MISSISSIPPI POWER & LIGHT COMPANY

SUBJECT: Grand Gulf Nuclear Station  
Units 1 and 2  
Docket Nos. 50-416 and 50-417  
File 0260/0277/L-860.0/L-952.0  
Transmittal of Responses to  
NRC Questions from ICSB  
AECM-80/225

Attachments: Responses to ICSB Questions

<p>MISSISSIPPI POWER &amp; LIGHT COMPANY          GRAND GULF NUCLEAR STATION          UNITS 1 &amp; 2          FINAL SAFETY ANALYSIS REPORT</p>	<p>REACTOR PROTECTION SYSTEM          SCRAM FUNCTIONS          FIGURE 7.2-2          AMEND. 39 5/80</p>
---	---

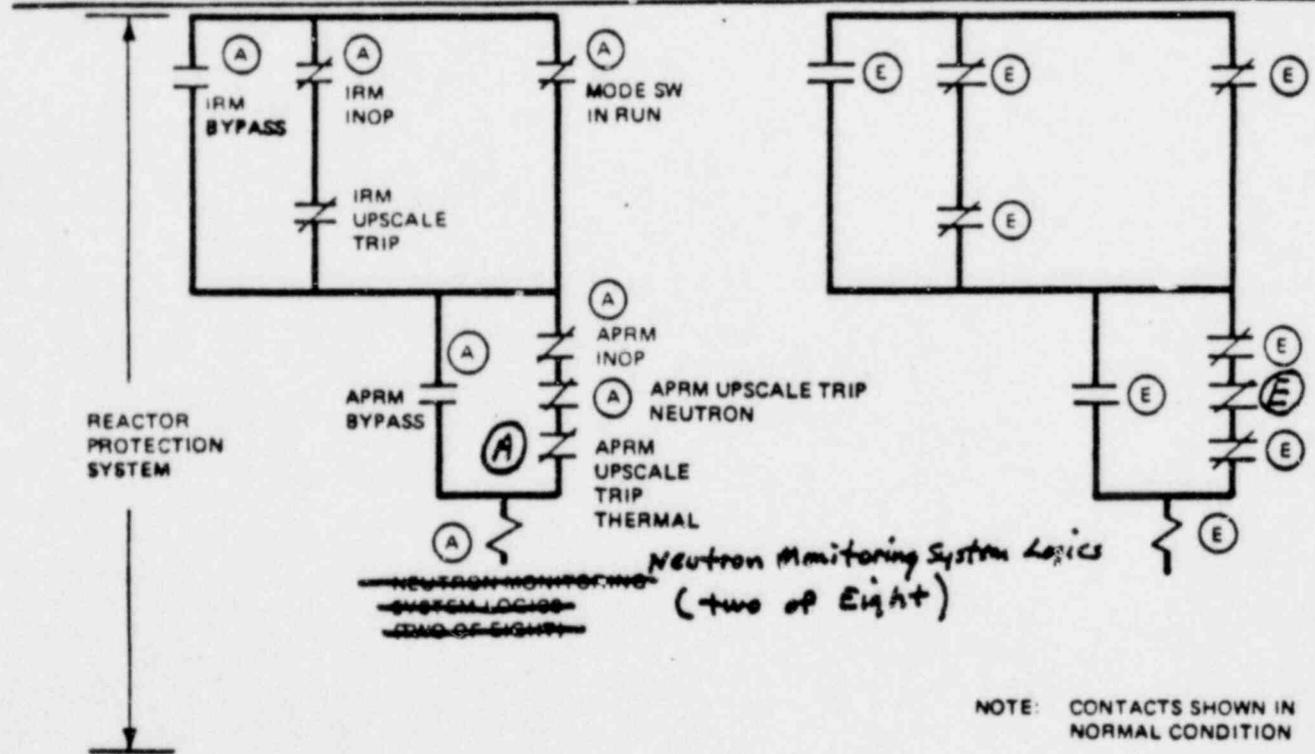
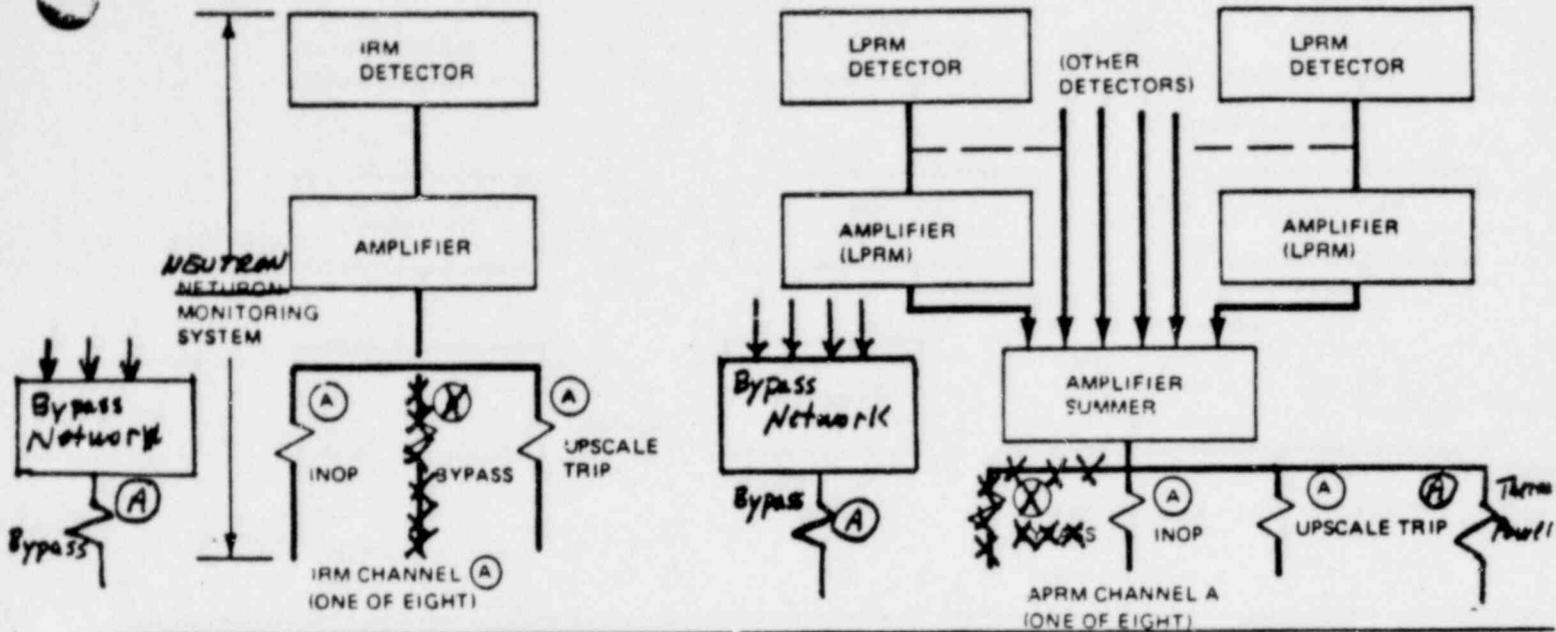
- (7) Revise Figure 7.2-2 to show that the APRM trip is not only operable in other modes than Run but that the setpoint is lower if the mode switch is not in Run.

7. Figure 7.2-2 has been revised to add the lower APRM setpoint for the non-Run mode condition.
8. Figure 7.2-5 is being revised in conjunction with Question 031.56.

CONFIGURATION FOR MAIN STEAM LINE  
ISOLATION REACTOR TRIP  
FIGURE 7.2-8  
AMEND. 39 5/80

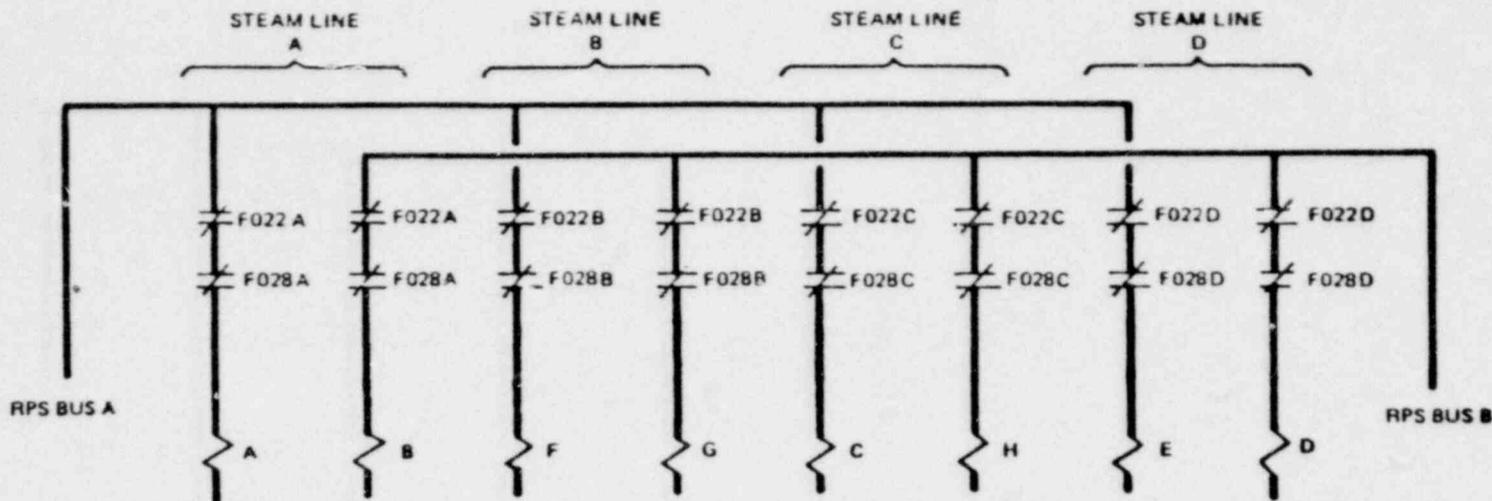
- (9) Resolve the discrepancy in the APRM trip functions between Figure 7.2-6 and Figure 7.6-12. )
- (10) Steam line B, Outboard Valve is misidentified in the key to Figure 7.2-8.

10. Figure 7.2-8 has been revised.
